# INSERVICE INSPECTION

REV. 12	ISO. NO.: MCFI - IVQ4	DUKE PIPING CLASS: B ASME SECT. III	BUILDING: REACTOR R7
REVISED TO ADD VENT VALVE DETAIL 'A' AND DELETE SUBASSEMBLY IVQ15 PER VN 11071	DUKE PIPING CLASS: B ASME SECT. III	SYSTEM SYMBOL: CONTAINMENT AIR REL. AND ADDITION	
REVISED TO ADD WELD VQIF 58		PIPING SPEC: VQ 02 PSI 51.2	
REVISED TO CHANGE MAT (E) TO 24"		DRAWING NO.: MC-1422-17.20-00	
REVISIONED TO ADD MATERIAL (E)		PROJECT: MCGUIRE	
ADD 90° ELL TO IVQP 14			
REL. FOR CONST. VN. 8310			
NO.	ORIG. CHKD. APPR.	DATE	DATE

NUCLEAR SAFETY RELATED

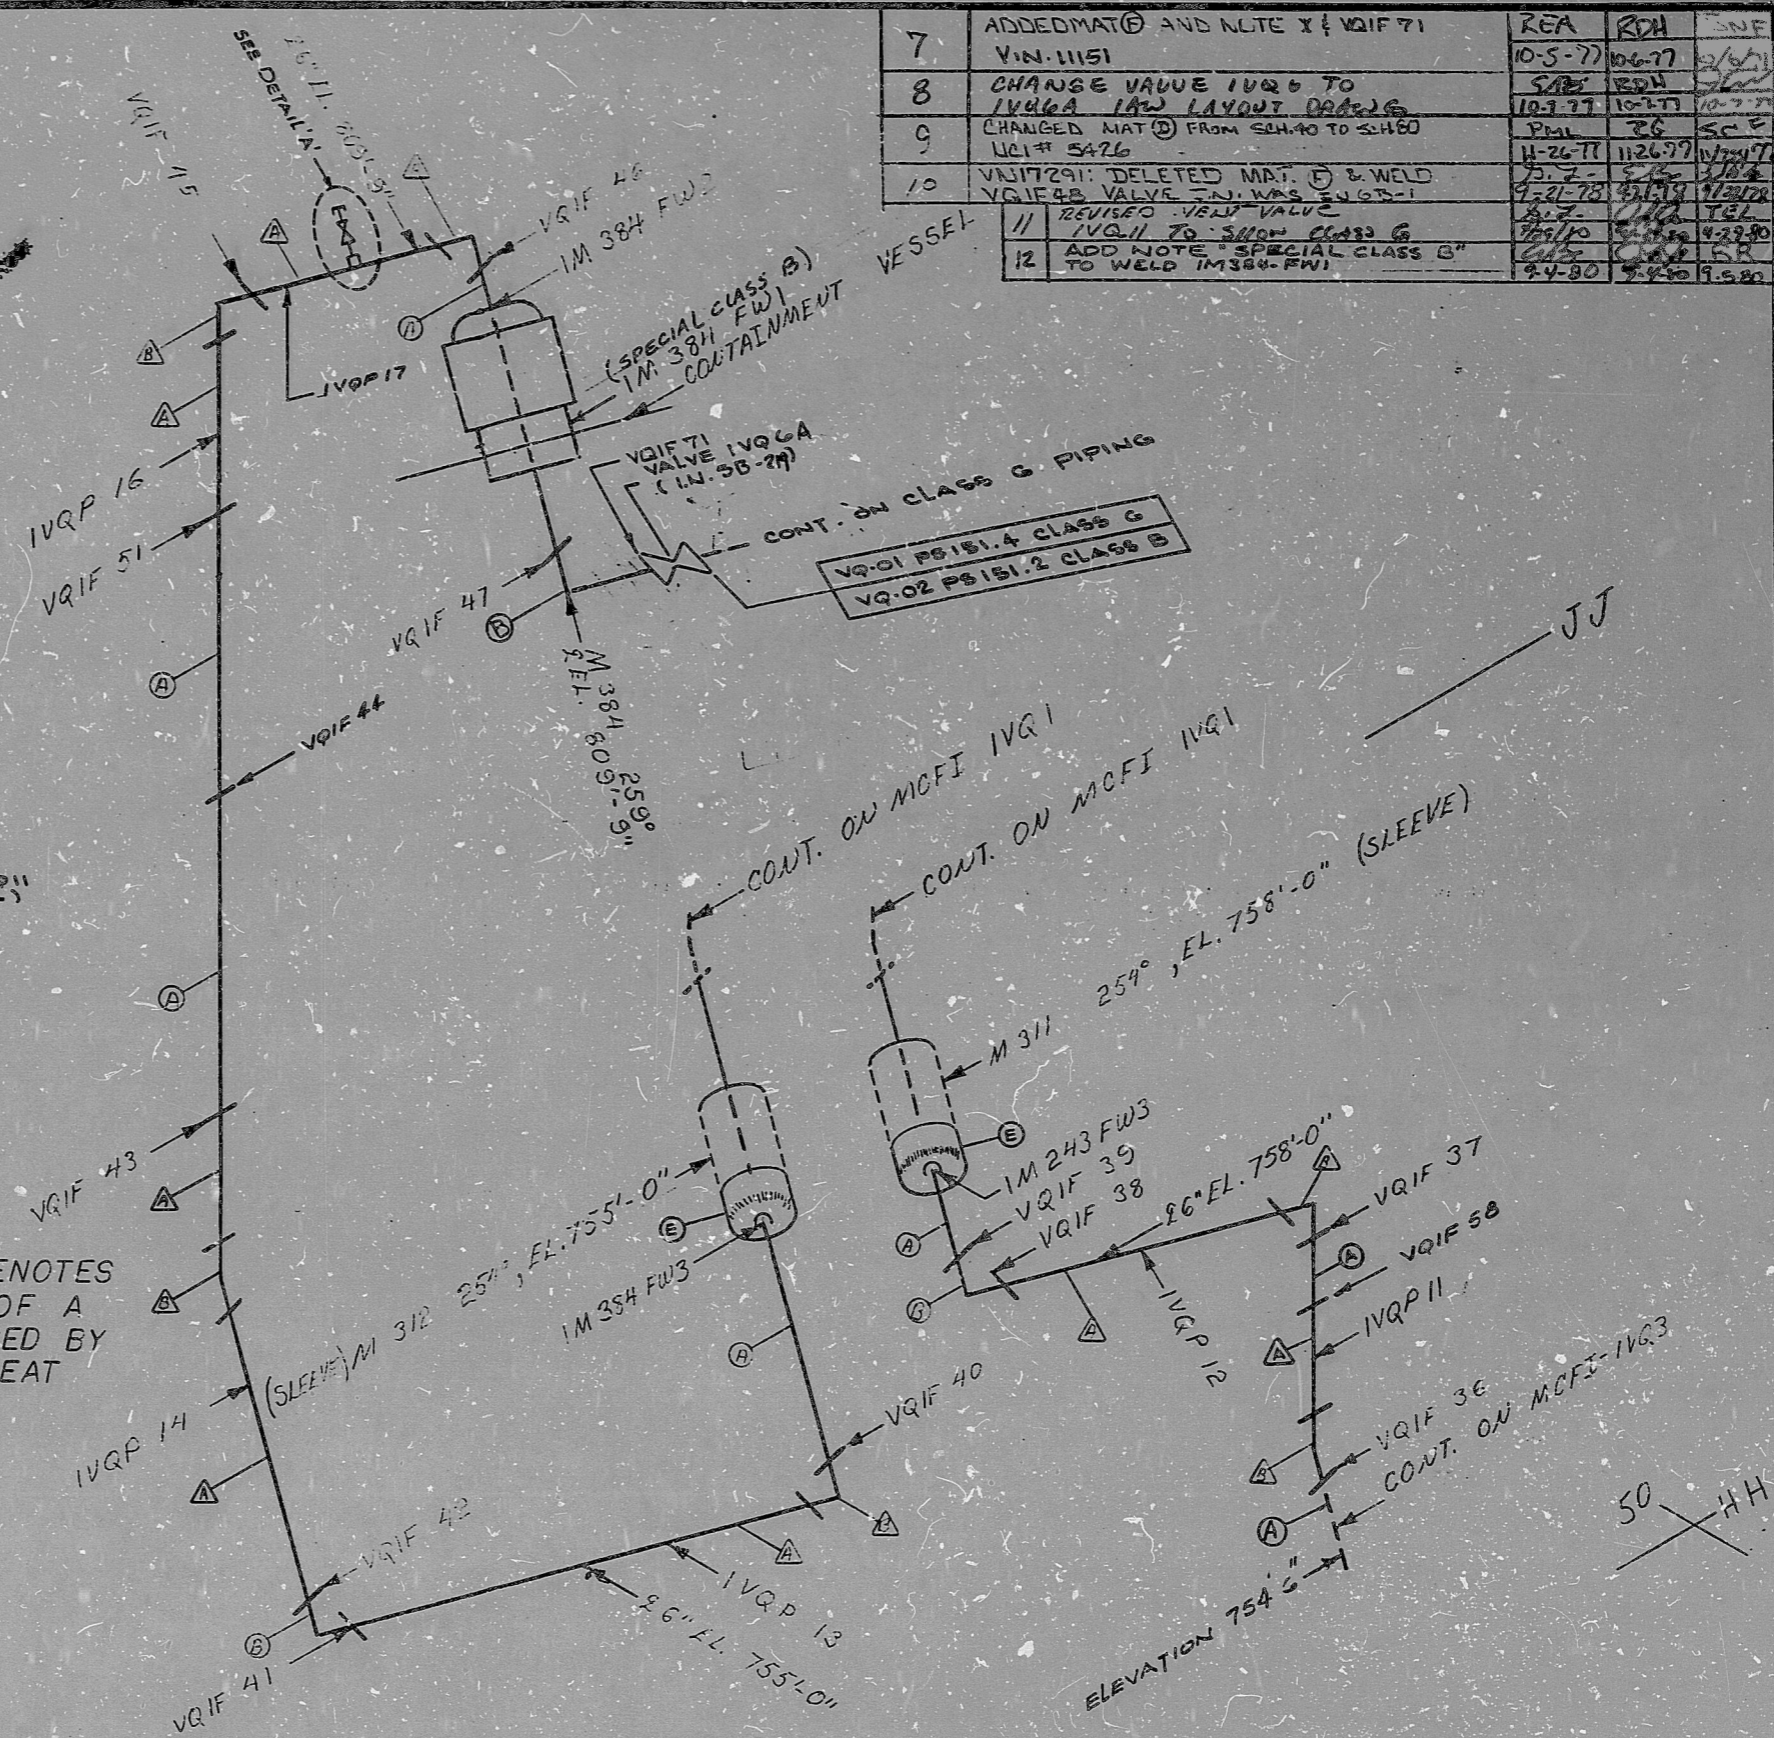
7	ADDED MAT ⑥ AND NLTE X & VQIF 71	REA	RDH	SNF
8	CHANGE VALVE 1VQ6 TO 1VQ6A IN LAYOUT DRAWING	10-5-77	10-6-77	10-7-77
9	CHANGED MAT ⑥ FROM SCH. 40 TO SCH. 80	10-7-77	10-7-77	10-7-77
10	VQIF 291: DELETED MAT. ⑥ & WELD VQIF 48. VALVE 1VQ6 WAS ENG. 2-1	11-26-77	11-26-77	11-26-77
11	REVISED VQIF VALVE 1VQ11 TO SHOW CLASS G	1-22-78	1-22-78	1-22-78
12	ADD NOTE "SPECIAL CLASS B" TO WELD 1M384-FW1	2-4-80	2-4-80	2-4-80
